FIGURE 3.4-1

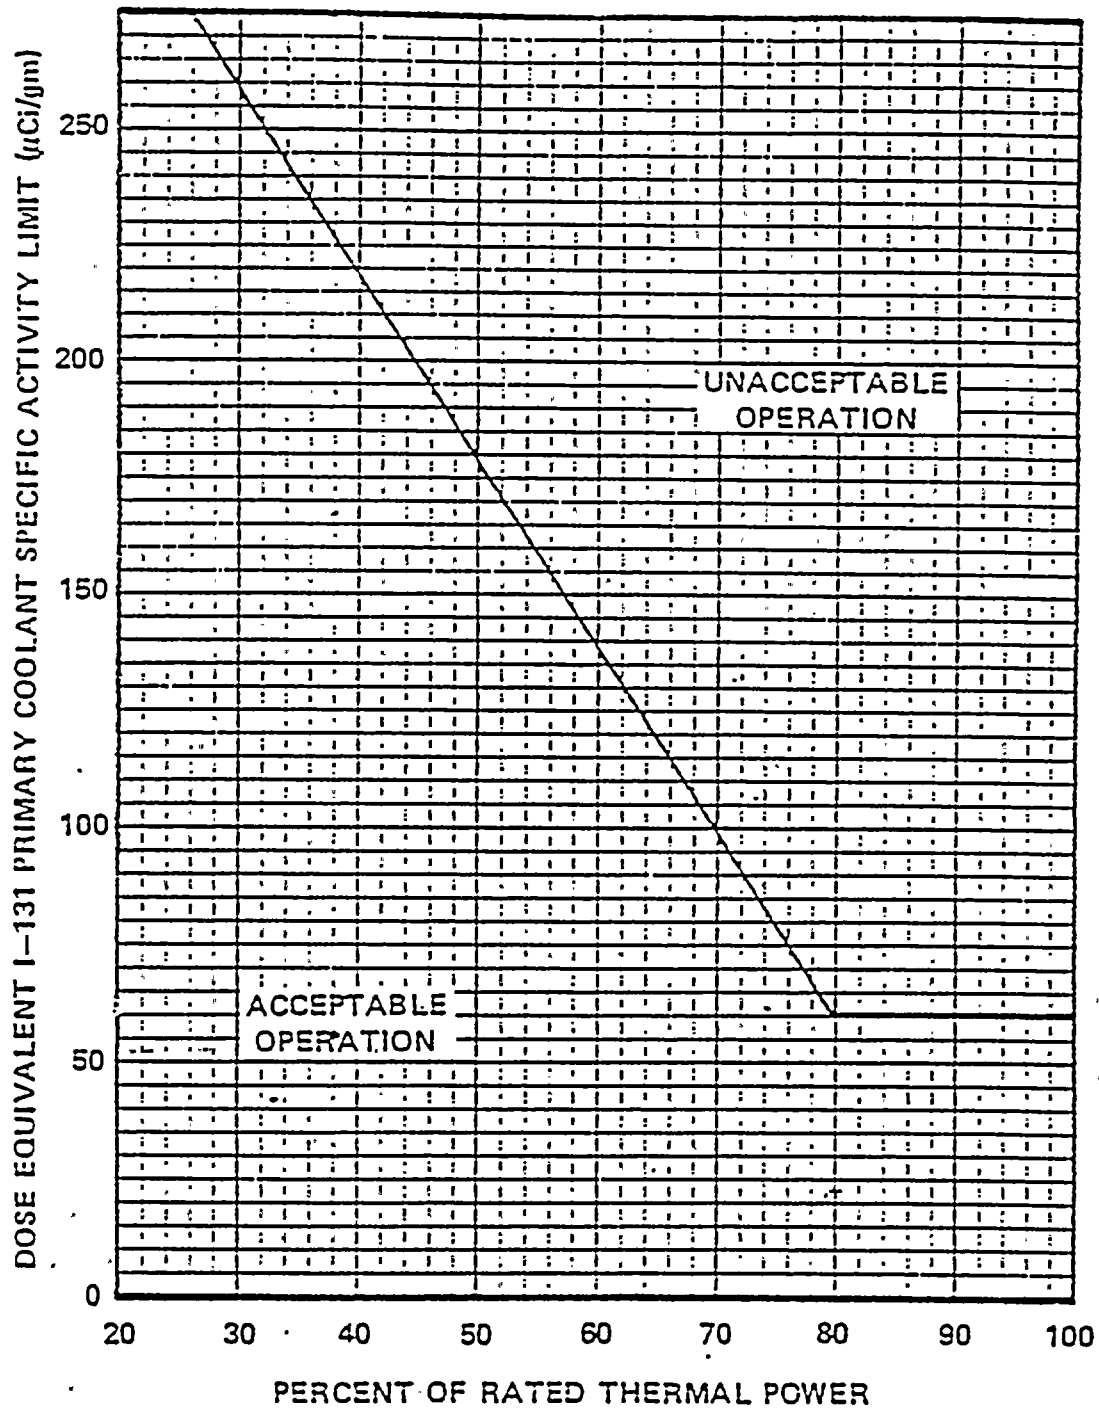
- With the specific activity of the primary coolant greater than 1.0 microcurie/gram DOSE EQUIVALENT I-131 ~~but within the allowable limit (below and to the left of the line) shown on Figure 3.4-1, operation may continue for up to 48 hours provided that the cumulative operating time under these circumstances does not exceed 800 hours in any consecutive 12 month period. With the total cumulative operating time at a primary coolant specific activity greater than 1.0 microcurie/gram DOSE EQUIVALENT I-131 exceeding 500 hours in any consecutive 6 month period, prepare and submit a Special Report to the Commission pursuant to Specification 6.9.2 within 30 days indicating the number of hours above this limit. The provisions of Specification 3.0.4 are not applicable.~~

- $100/\bar{E}$ microcurie/gram DOSE EQUIVALENT I-131 ~~for more than 48 hours during one continuous time interval or exceeding the limit line shown on Figure 3.4-1, be in at least HOT STANDBY with T_{cold} less than $500^{\circ}F$ within 6 hours.~~
